Subject: Class 2 Permit Modification Request, Waste Isolation Pilot Plant Hazardous Waste Facility Permit Number: NM4890139088-TSDF

- Addition of Four New Shielded Containers
- Revise Site Recertification Audit Scheduling from Annual to Graded Approach

Class 2 Permit Modification Request
Addition of Four New Shielded Containers
and
Revise Site Recertification Audit Scheduling from Annual to Graded Approach
Waste Isolation Pilot Plant
Carlsbad, New Mexico
WIPP Permit Number - NM4890139088-TSDF

Figure M-11
Range of Typical Shielded Container Dimensions

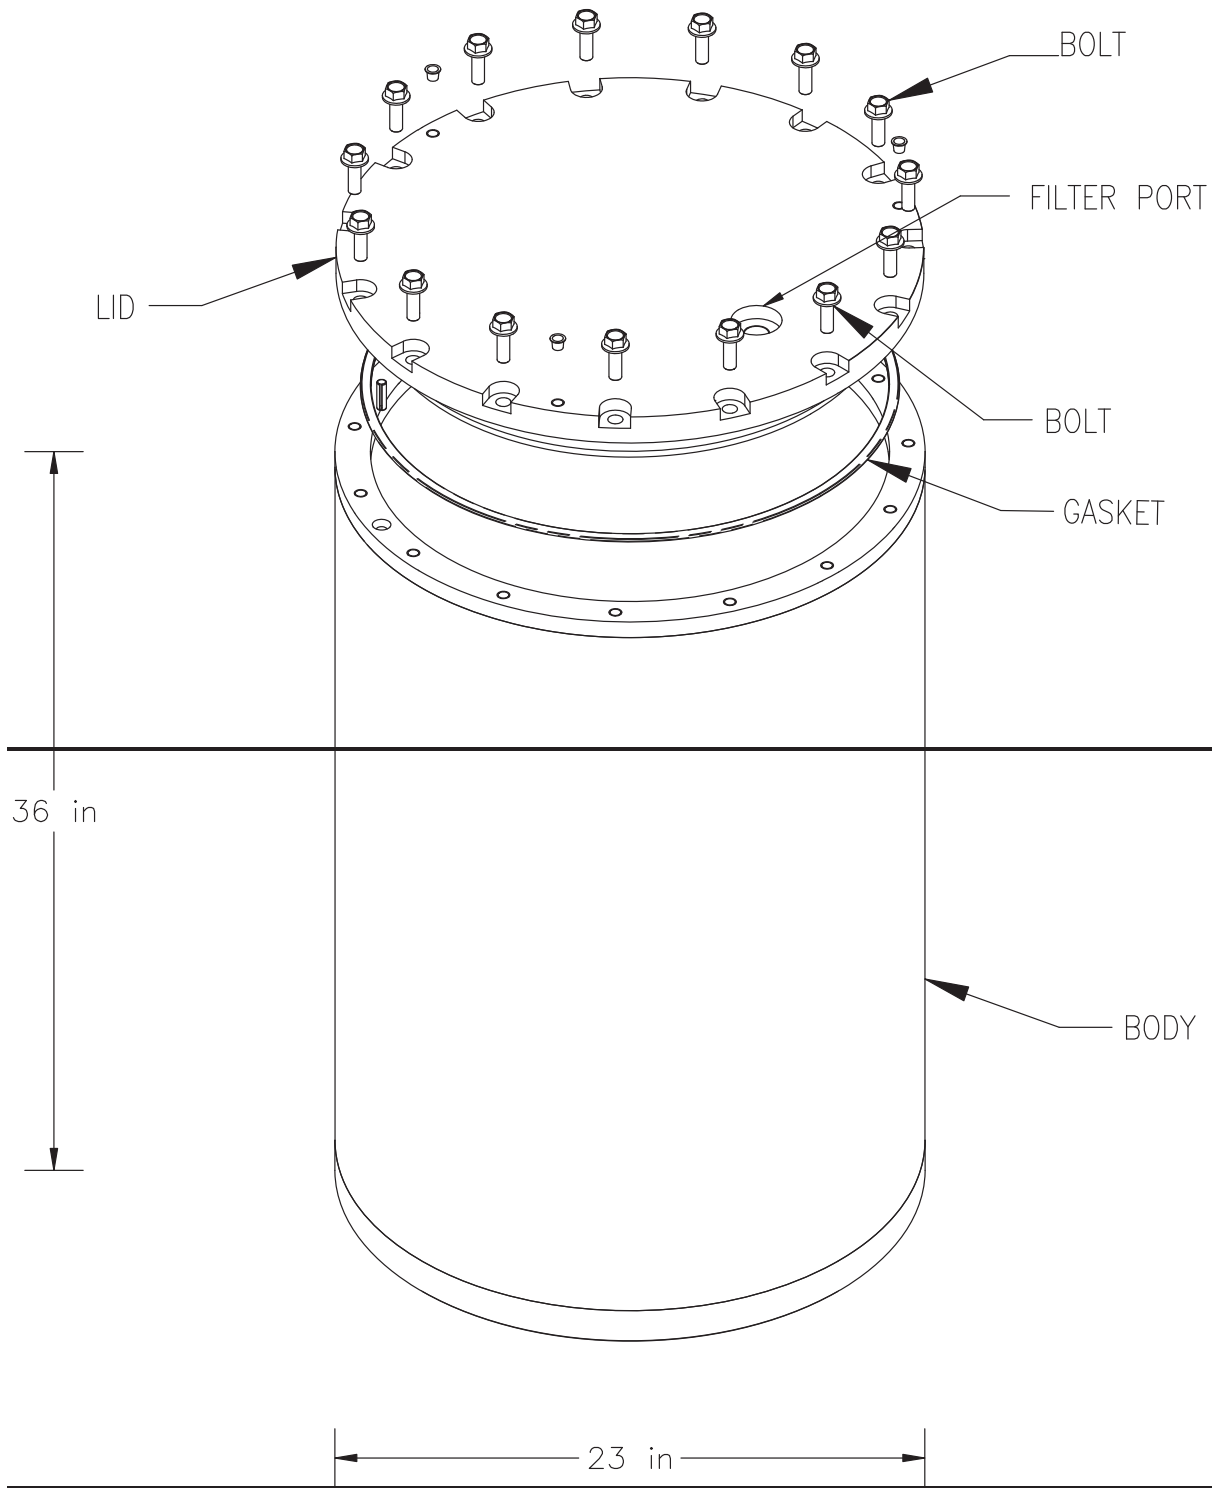
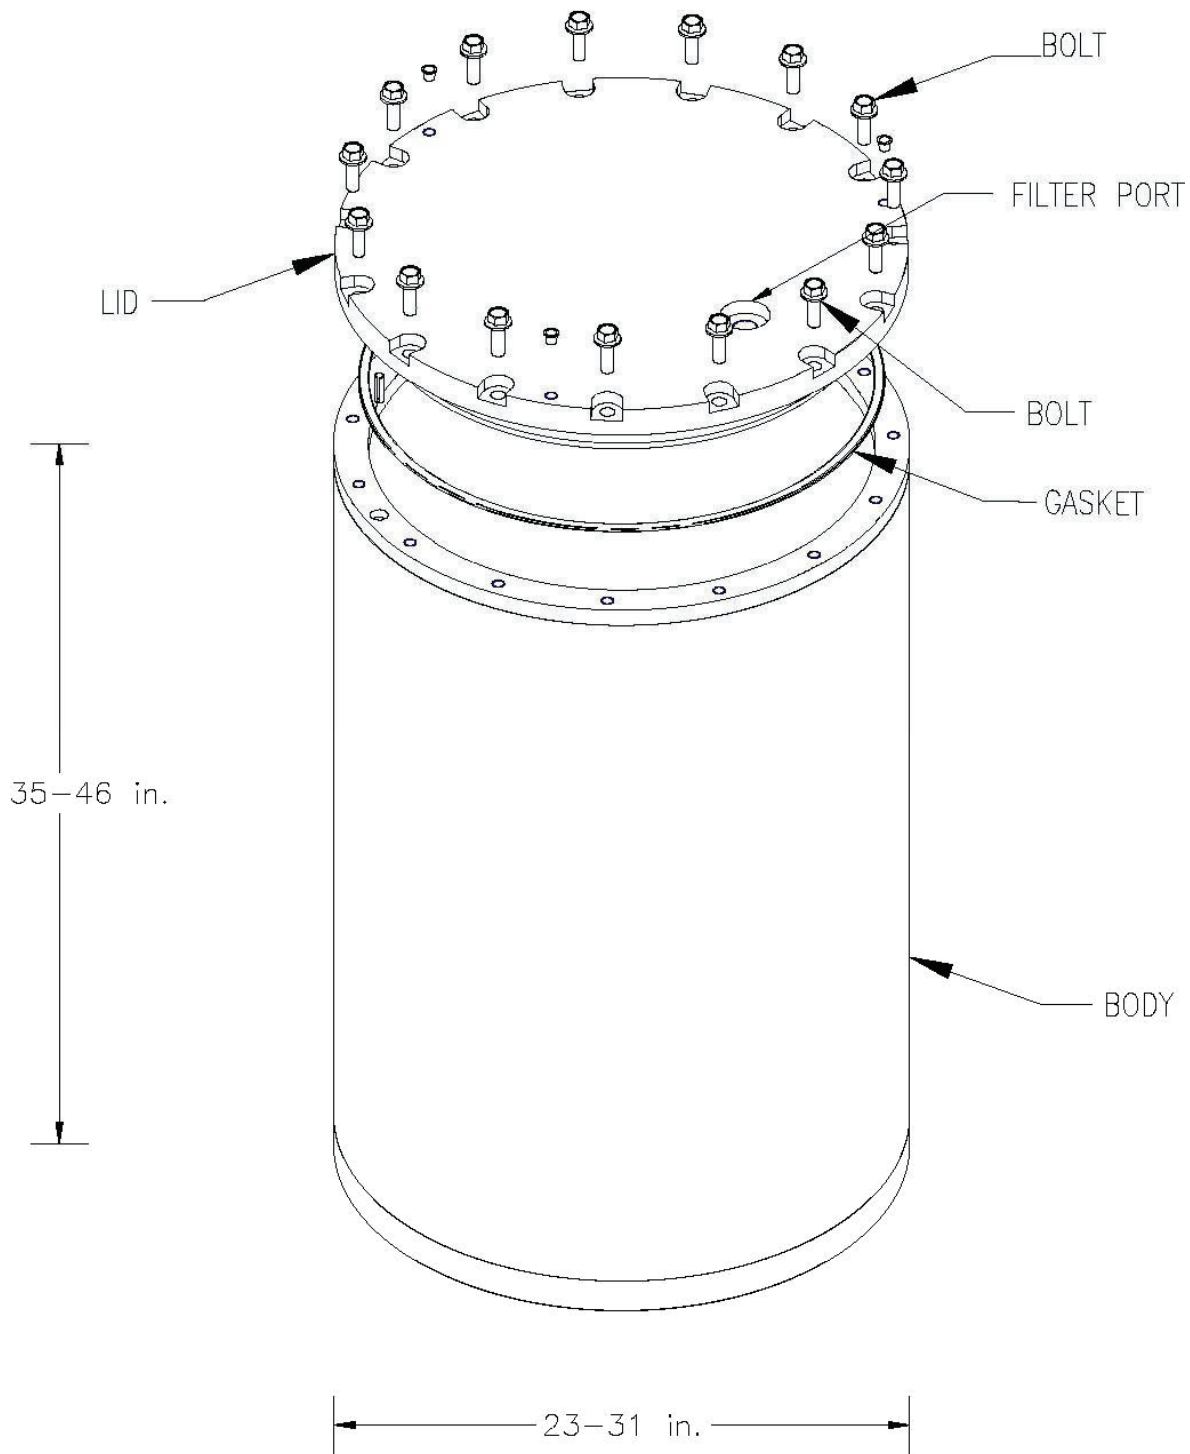
- Revised Permit Attachment M, Figures, Figure M-11, *Typical Shielded Container*, to update the figure to a range of dimensions and update the figure title.

<p>Attachment E, Table E-1, <i>Inspection Schedule/Procedures</i></p>	<p>Added new line for "SCA Handler" inspection with the following specific information: added "SCA" to the System/Equipment Name column, "Waste Operations" to Responsible Organization column, "Preoperational" to Inspection Frequency column, and the "WP-05-WH1450 Inspecting for Mechanical Operability^m and Deterioration^b to the Procedure Number and Inspection Criteria^h column.</p>
<p>Attachment M, <i>Figures, List of Figures</i></p>	<p>Modified the language for Figure M-11 from: "Typical Shielded Container" to: "Range of Typical Shielded Container Dimensions"</p>
<p>Attachment M, <i>Figures, Figure M-11, Typical Shielded Container</i></p>	<p>Modified the language on Figure M-11 from: "Typical Shielded Container" to: "Range of Typical Shielded Container Dimensions"</p>

Affected Permit Section	Explanation of Change
	Replaced the vertical measurement of "36 in" with "35-46 in"
	Replaced the horizontal measurement of "23 in" with 23-31 in"
